FOLLOW-UP COMMENTS ON JUNE 1984 DOE/NRC HYDROGEOLOGY WORKSHOP1.0 Background

In July 1983, a general agreement was reached between NRC and BWIP regarding a testing approach appropriate for partial hydrogeologic characterization of the BWIP site. The summary of general understandings reached during the July 1983 workshop is attached (Attachment 1). On the basis of discussions during the July 1983 Workshop, the NRC developed a Draft Site Technical Position (STP 1.1) on a hydrogeologic testing strategy for the BWIP site. The intent of STP 1.1 (1983) is to guide BWIP on a general approach to testing that is appropriate to develop and acquire information needed for licensing.

FIGURE 1

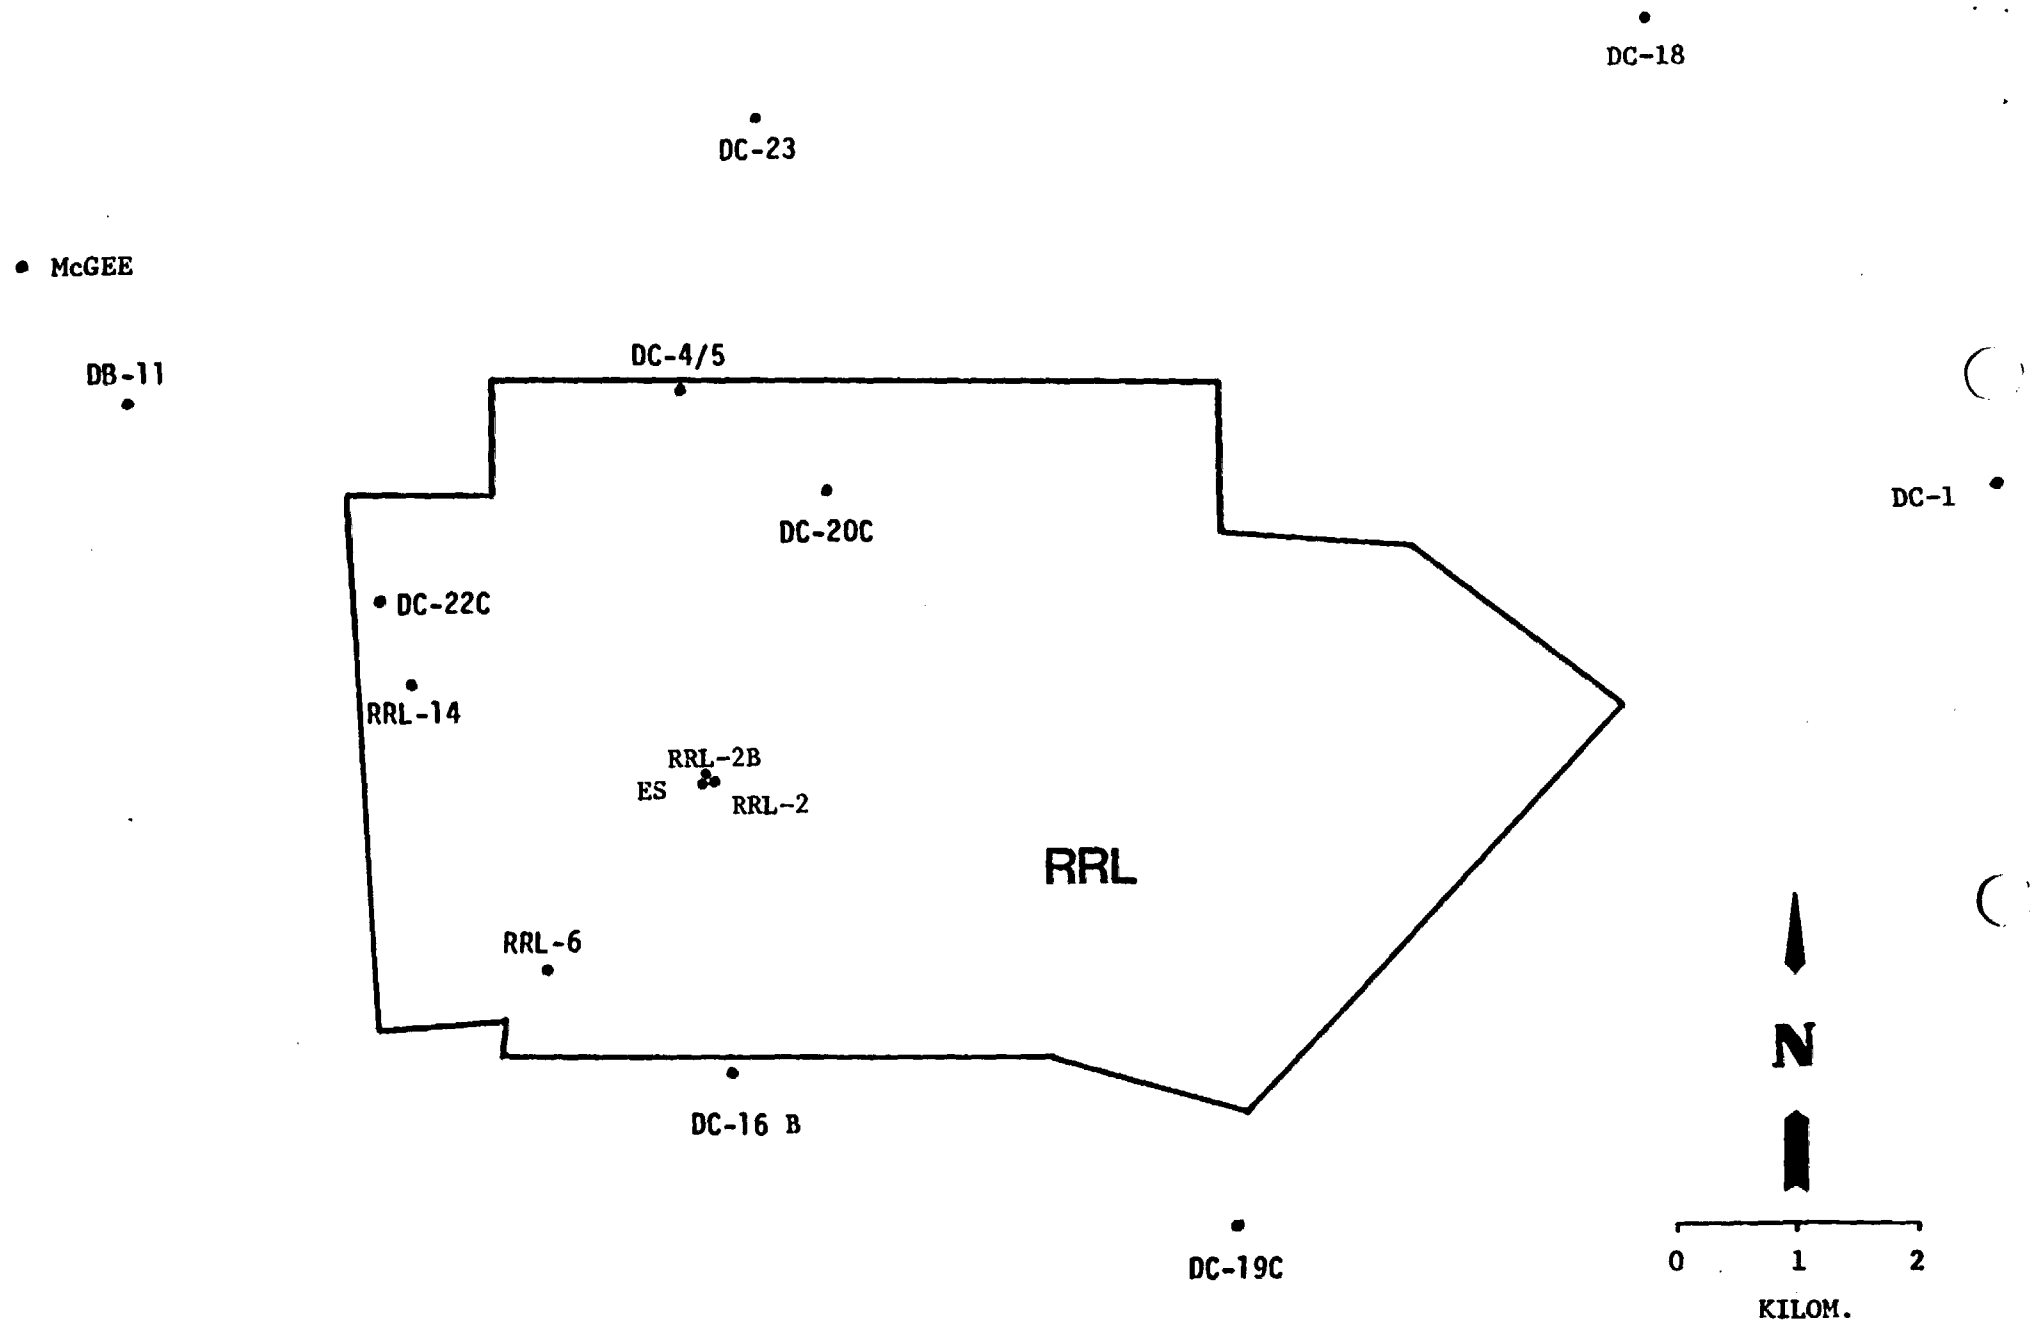
During the June 1984 NRC/BWIP Hydrogeology Workshop, BWIP presented an updated description of the status of and plans for hydrogeologic monitoring and testing at the BWIP site. The presentations indicated that substantial progress had been made toward implementation of the testing strategy discussed during the July 1983 meeting. In particular, the nested piezometers in boreholes DC-19C, DC-20C and DC-22C had been installed with reasonable success, and the hydrologic baseline monitoring had begun. In addition, the feasibility of the planned large-scale hydraulic stress (LHS) tests was clearly demonstrated by observations of drawdowns in DC-16B, DB-14, and DC-1 during air-mist drilling of the cluster "C" holes. Throughout this document please refer to Figure 1 which illustrates, relative to the boundaries of the Reference Repository Location (RRL), the locations of most of the boreholes discussed in this letter.
